Motor Retainer Upgrade Notice

ARREAUX Kit

Your kit now includes a new improved screw-on motor retainer. Please follow these instructions.

REVISED LOCATION GUIDE

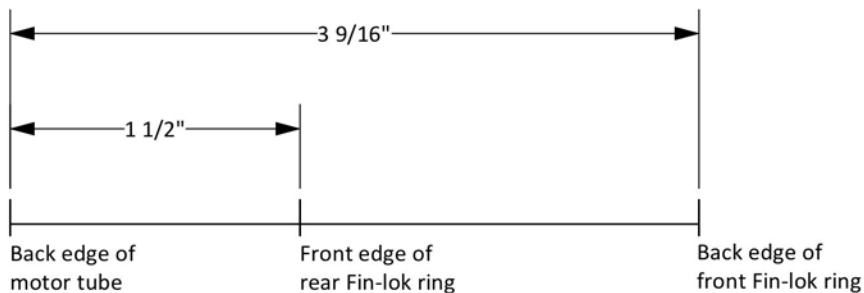
Use the LOCATION GUIDE above to make pencil marks along the motor tube line for location of the FIN-LOK rings per STEP 3. The new marks will move the motor tube rearward so that it is flush with the end of the body tube.

Follow Step 1 of FIN-LOK ASSEMBLY using new location marks as above.
